TECH Information

Object: : Improvement of Swing Arm

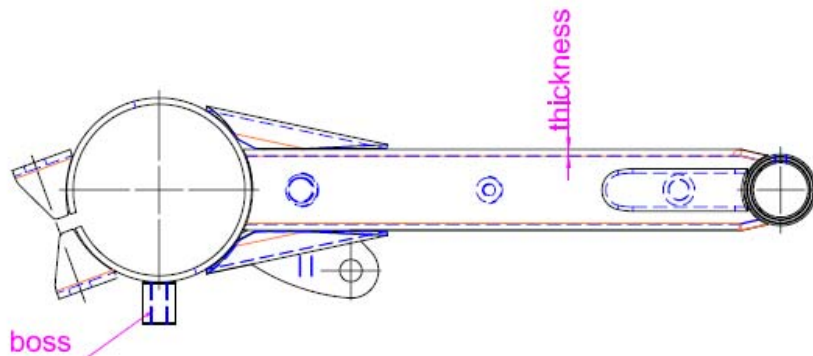
We had got information about swing arm, it could get break on square tube when bike gets the heavy jump. Therefore we will improve the swing arm as following items. Please kindly refer the following drawing.

1. Thickness of square tube, the original is 2mm and we will use 3mm for new production. The improvement will get solution even bike gets heavy jumping.
2. The boss of swing skid plate, we will not welded the boss on swing arm because the welded of boss will get trouble on production. The circle tube could be deformed, when the bosses are welding and get heat. Due to this revised, we will offer the stay as picture. Please kindly make reference.
